PLANNING AND ZONING BOARD STAFF REPORT

Spodak Dental - Expansion

Request
 Consideration of a Level 3 Site Plan Application with Landscape Plan and Architectural Elevations for a 2,668 square foot addition to an existing approximate 13,000 square foot medical office building.

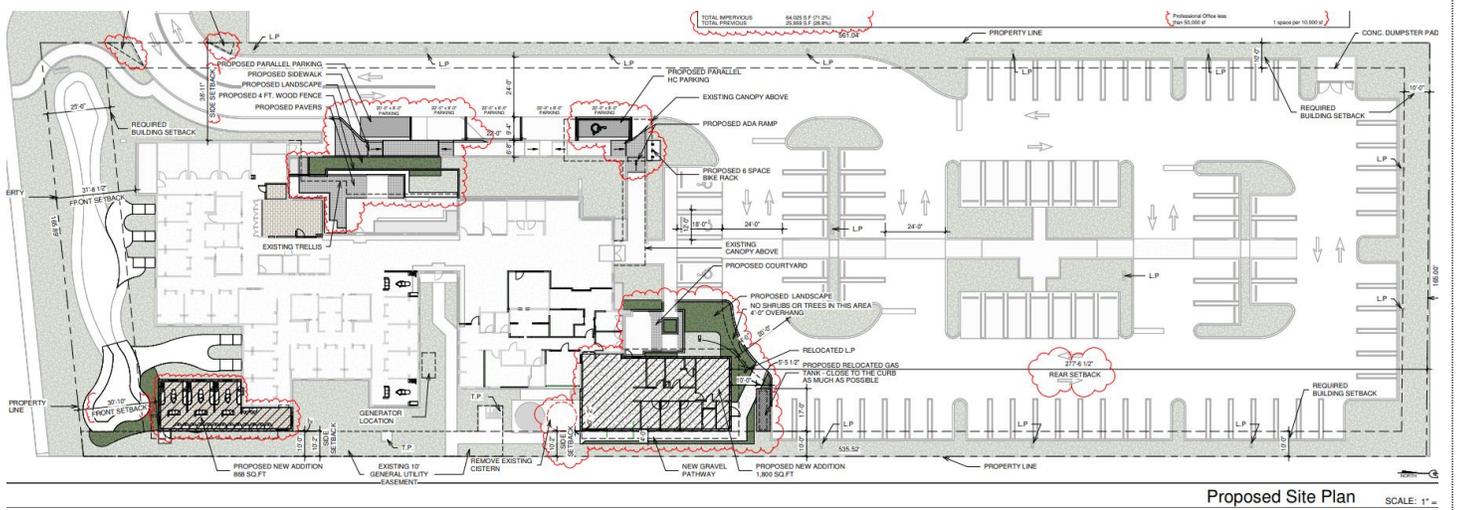
The development proposal includes two additions to the existing building and other related site modifications. Specifically, an 868 square foot addition is proposed in the southeast corner of the building, where the required front and side interior setback is still maintained; and an 1,800 square foot addition is proposed in the northeast corner of the existing building, where the requisite rear and side interior setback is also maintained. The architectural style of the proposed expansion is a consistent and well-integrated continuation of the style of the existing building. The architecture is found to be in compliance with the requirements of LDR Section 4.6.18.

Modifications along the west façade of the building include the expansion of an outdoor employee lounge area partially covered by a trellis. Along the entrance drive aisle, the previous drop-off area has been converted to permanent parallel parking. The existing loading zone adjacent to the northeast addition has been removed to accommodate the expansion of the building. Pursuant to LDR Section 4.6.10, the removal of the existing loading zone and approval of the site plan is contingent on the Board making a determination of adequacy by finding that the use is able to successfully meet the expected loading demand through an alternative method when no defined loading area is proposed.

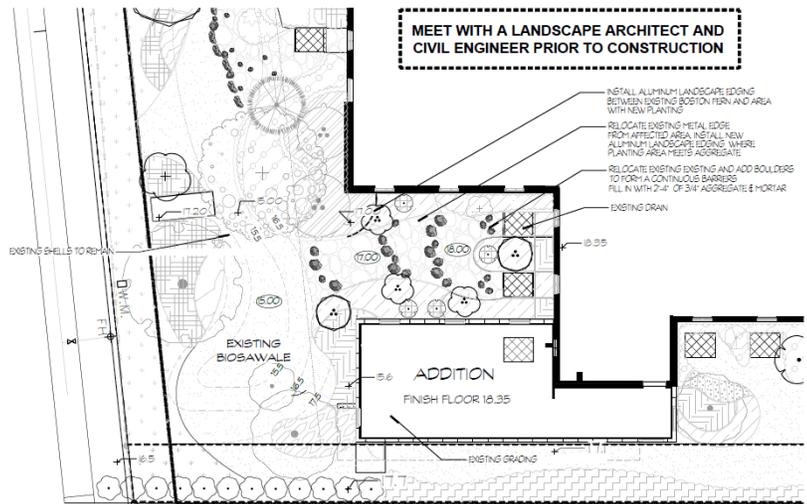
Foundation and perimeter landscaping around the addition are proposed to meet the requirements for the new area. The detail for the landscaping on the southeast corner addition is shown at right.
